**MONTGOMERY COUNTY HISTORIC PRESERVATION COMMISSION**  
**STAFF REPORT**

<b>Address:</b>	7300 Holly Ave., Takoma Park	<b>Meeting Date:</b>	3/8/2023
<b>Resource:</b>	Outstanding Resource <b>Takoma Park Historic District</b>	<b>Report Date:</b>	3/1/2023
<b>Applicant:</b>	Fernando Angulo	<b>Public Notice:</b>	2/22/2023
<b>Review:</b>	HAWP	<b>Tax Credit:</b>	n/a
<b>Case Number:</b>	1016595	<b>Staff:</b>	Dan Bruechert
<b>Proposal:</b>	Partial Demolition and Building Addition

The applicant proposes partial demolition and construction of an addition to the house.

**ELEVATIONS**

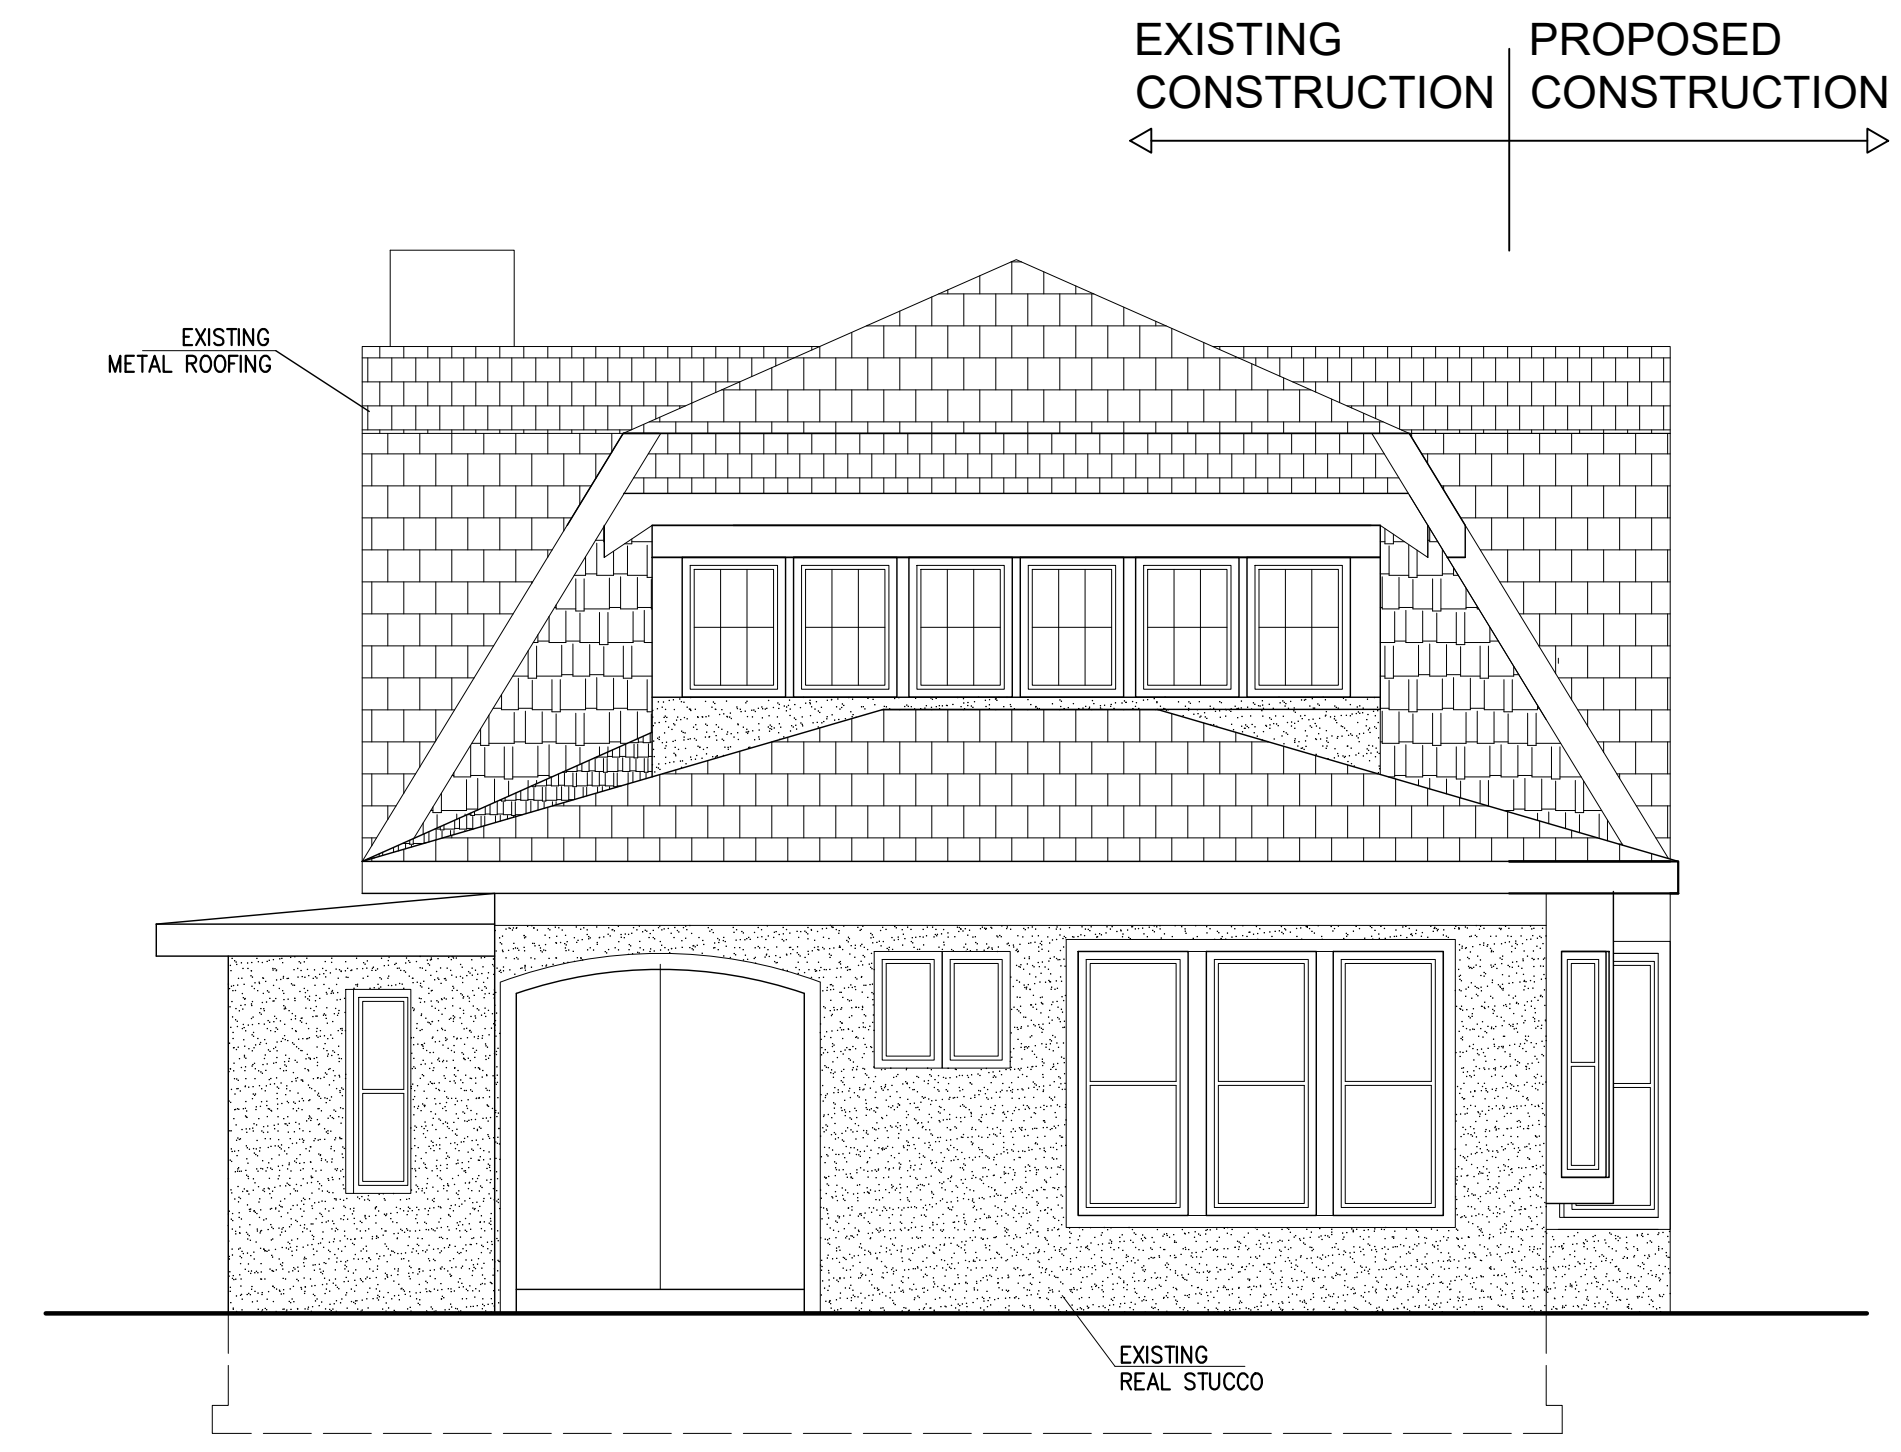
Staff finds the proposed materials are all appropriate, with one notable exception, the roof material. The elevation drawings incorrectly label the existing roof as asphalt shingle, when it is a mix of metal shingles and flat metal. Staff finds because of the visibility of the proposed addition's roof, shingles matching the historic house should be used. The *Design Guidelines* state, "Plans for all alterations should be compatible with the resource's original design; additions, specifically, should be sympathetic to existing architectural character, including massing, height, setback, and materials." The existing roof was installed in 2008 as an in-kind replacement and Staff's files identify the installed metal shingles as Berridge Victorian shingles: <https://www.berridge.com/products/shingle-systems/victorian-shingles/>. HP Staff photos show the condition of the roof prior to the installation of this roof:

Staff finds while the new shingles would initially have a shinier appearance than the existing shingles, they will patinate over time and blend in with the house architecture. While a red asphalt shingle could match the color of the existing roof and provide a dull appearance out of the box, they lack the other visual and physical qualities of the shingles and are inconsistent with the house's architecture. Staff recommends the HPC approve the HAWP under 24A-8(b)(5) and the *Design Guidelines* with the added condition that the new roofing is metal shingle to match the house. Final approval authority to verify this condition has been satisfied can be delegated to Staff.

1. The proposed asphalt shingles are inconsistent with the existing metal shingles. Metal shingles matching the appearance of the existing roof shall be installed on the addition. Final approval authority to verify this condition has been met is delegated to Staff.
